**LITTLE ROCK  
HISTORIC  
DISTRICT  
COMMISSION**

**LITTLE ROCK HISTORIC DISTRICT COMMISSION  
AGENDA FOR MEETING**

**STAFF REPORT  
ITEM NO. A.**

**ADDRESS:** *904-906 Commerce Street*

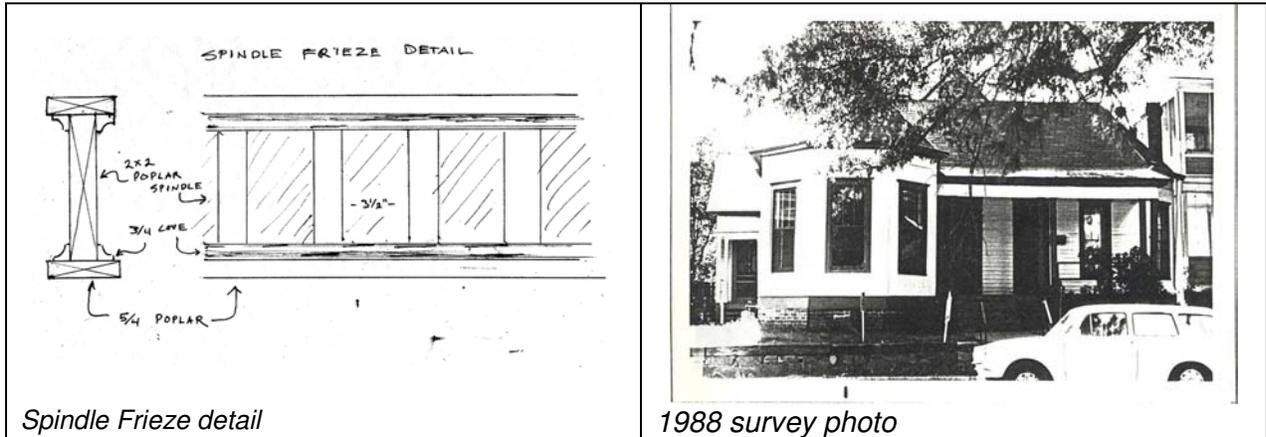
The proposal is divided into three parts. The first part is "Siding and Trim." Most of this normally could have been handled with a COC, but the applicant has desired to replace the vertical shiplap siding that is evident on the front bay with horizontal 6" weatherboard to match the rest of the house. This is shown in the photos above and particularly in the photo labeled "2007 Survey photo south side" and "Current Photo front with tower." In the 1988 photo, the

vertical siding was evident. This vertical siding was approximately 9-12" wide and had a shiplap edge. To replace with horizontal 6" weatherboard would be a change in materials and design and would require a COA.

The first part of the application is the Siding and Trim. Again, the replacement of broken cracked and warped pieces of siding and trim with pieces of same profile and size is usually a matter of COC’s. However, the removal of a large characteristic accent siding as the vertical shiplap siding is not appropriate for a contributing house. The vertical siding is a defining element on the façade of this house. Replacing it with horizontal weatherboard is not appropriate.

1. Obtaining a building permit.
2. Approval of the following items:
  1. Replacement of broken cracked and warped pieces of siding and trim with pieces of same profile and size.
  2. Decking on front porch.
  3. Railings on front porch with extension to location of removed bench.
3. Denial of the following items:
  1. Replacing vertical siding with horizontal weatherboard.
  2. Built-in bench on front porch.
  3. 8x8 fiberglass columns on front porch.
  4. Spindle frieze detail.
  5. Replacement vinyl windows.

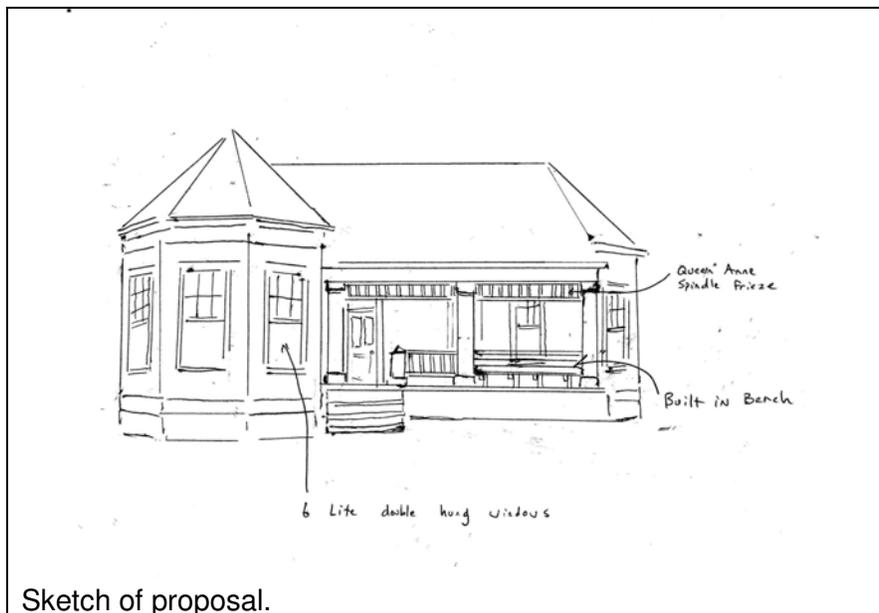
The second part is "Front Porch Rebuild." This was the original violation observed by Staff. The front porch decking was removed and replaced without a COA or COC. It was replaced with 5/4" pressure treated wood. New stairs were added along with new handrails along stairs. The new handrails are made of 4x4 posts with 2x4 rails and 2x2 poplar spindles. The double columns, as shown in the photos above, were replaced with square 8x8 fiberglass columns. The detailing of the posts caps and bases were eliminated.

A built-in bench forms the railing along the front of the porch. The 1988 photo shows a very utilitarian railing on the porch, one that was probably not original to the house. See photo above labeled 1988 Survey Photo. A handrail was installed on the south half of the porch as described.

The second portion of the application is the Front Porch Rebuild. The replacing of the porch decking and handrails is simple enough to blend with the structure. The replacing of the posts on the porch with ones that are twice the size of the original also removed character-defining elements of the house. The built-in in bench in not in keeping whatsoever with the period of the house. The bench should be removed and replaced with more handrails to match the new handrails. The new columns should also be removed and the older posts replicated.

1979 photo from QQA files at ASI.

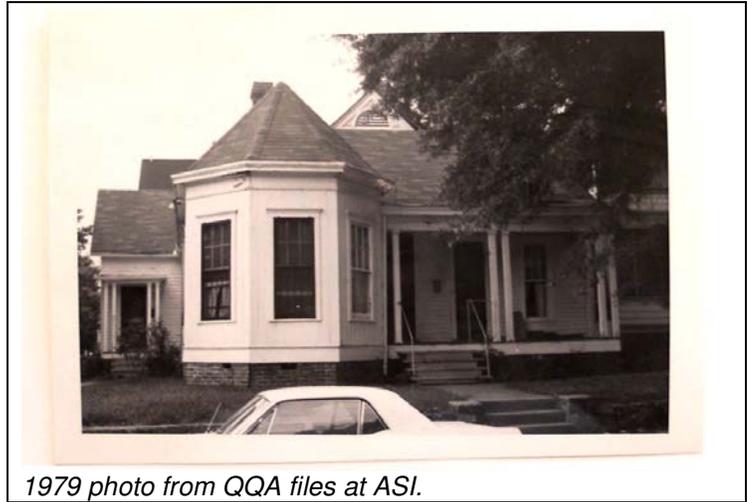
Staff has researched the address from the QQA files at the ASI. General photos of the park did not reveal any photos of the structure in question. A photo was found from 1979 and is shown below. The photo shows that the house has not had major improvements since 1979, except for the work that is the subject of this COA. It does show that there was not a railing on the porch at that time. It does clearly shows the dual column treatment on the porch.

The house is a contributing structure to the MacArthur Park National Register Historic District. The district was designated in 1977 and resurveyed in 2006. It is a contributing structure "as is." To add additional ornamentation to this structure would not comply with the Secretary of interiors Standards #3, which states: "Each property shall be

3. Obtaining a building permit.
4. Approval of the following items:
  1. Replacement of broken cracked and warped pieces of siding and trim with pieces of same profile and size.
  2. Decking on front porch.
  3. Railings on front porch with extension to location of removed bench.
3. Denial of the following items:
  1. Replacing vertical siding with horizontal weatherboard.
  2. Built-in bench on front porch.
  3. 8x8 fiberglass columns on front porch.
  4. Spindle frieze detail.
  5. Replacement vinyl windows.

Fencing Plan

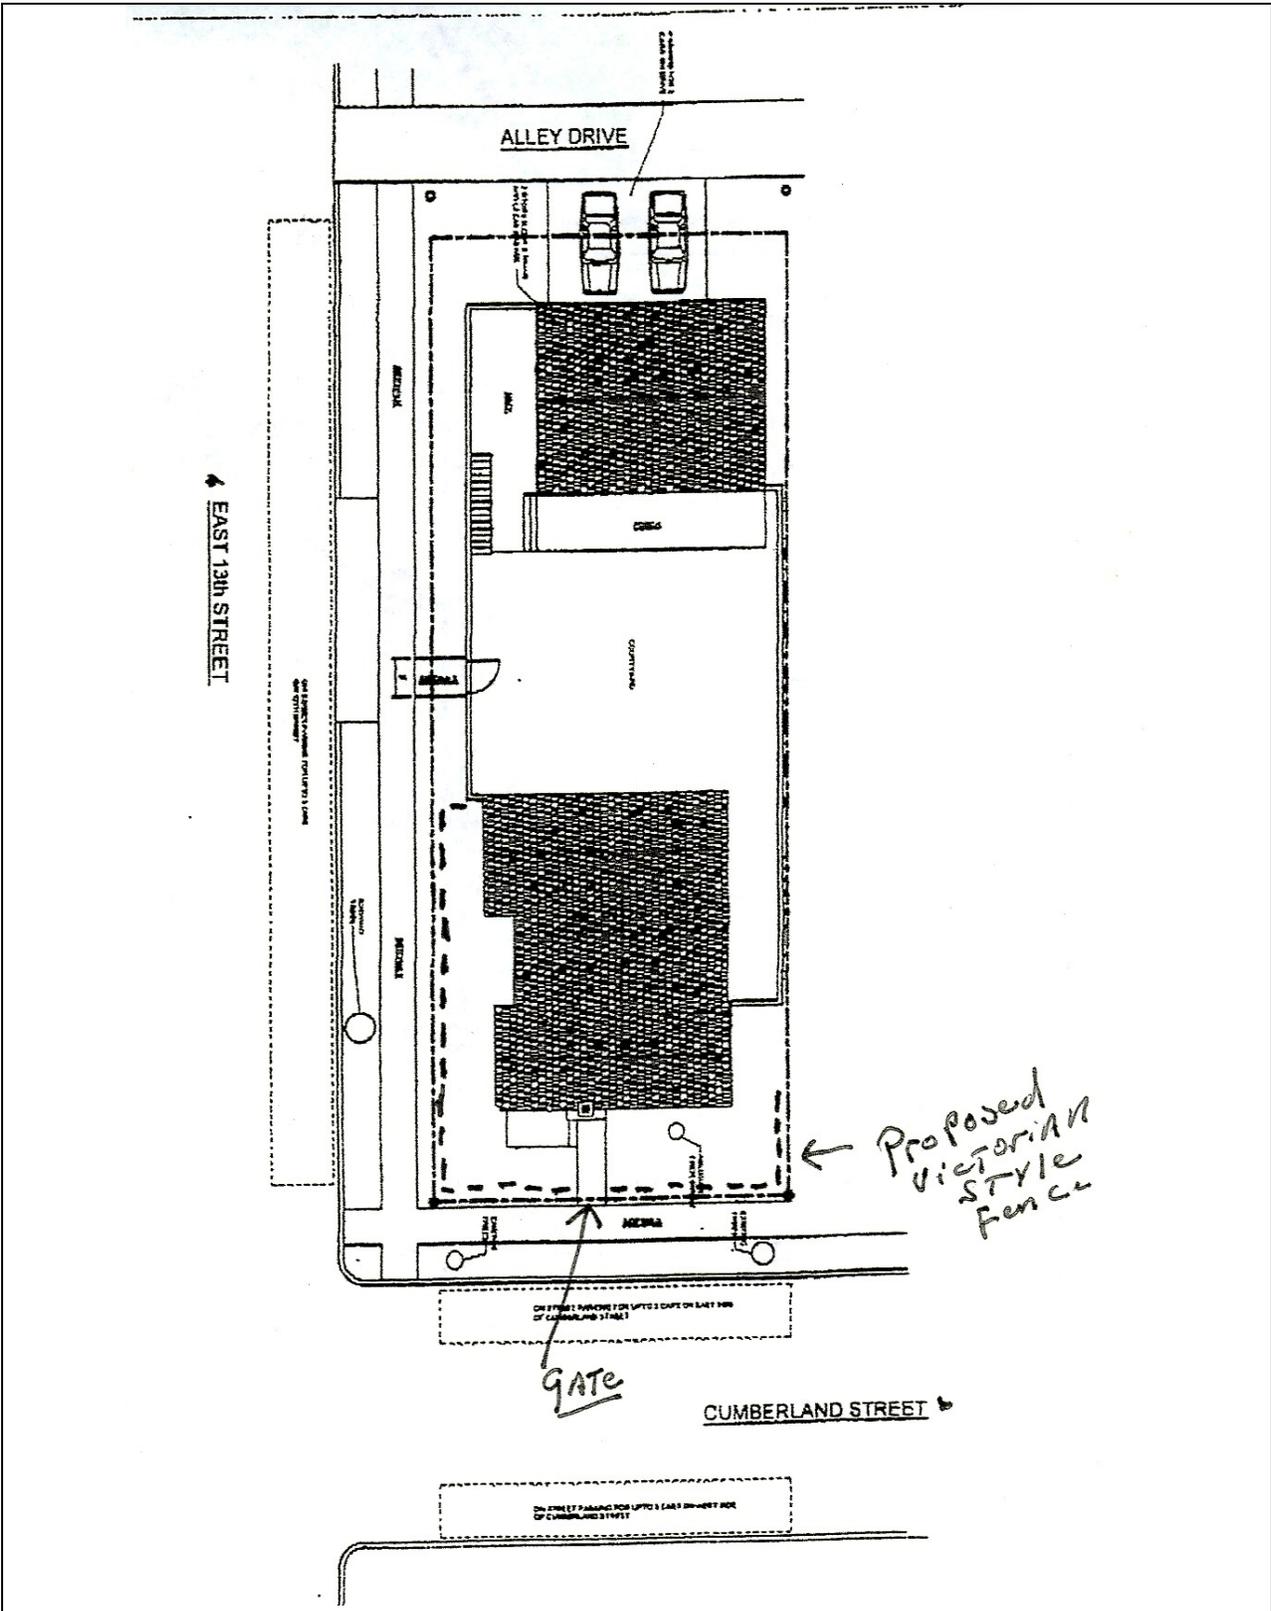
In the letter from the applicant dated August 16, 2011, the applicant states that the existing fence will be modified and placed at the end of the proposed fence. The applicant has not stated how that fence will be modified. If the fence materials were to be used to create more linear footage of the new proposed fence, that could be appropriate. Staff does not feel that it is appropriate have three discernable types of fencing on the property. Staff does support the addition of the proposed fence in the locations noted on the submitted plan as shown at the end of this report. Staff does not support additional locations of fences that are not shown in the submitted plans.

1. Obtaining a building permit.
2. Removal of the existing fence at the northwest corner of the house with the first phase of the fence installation.
3. Gate and gateposts shall be same height as the fence. Gateposts may be larger in width, but not in height to the other posts.
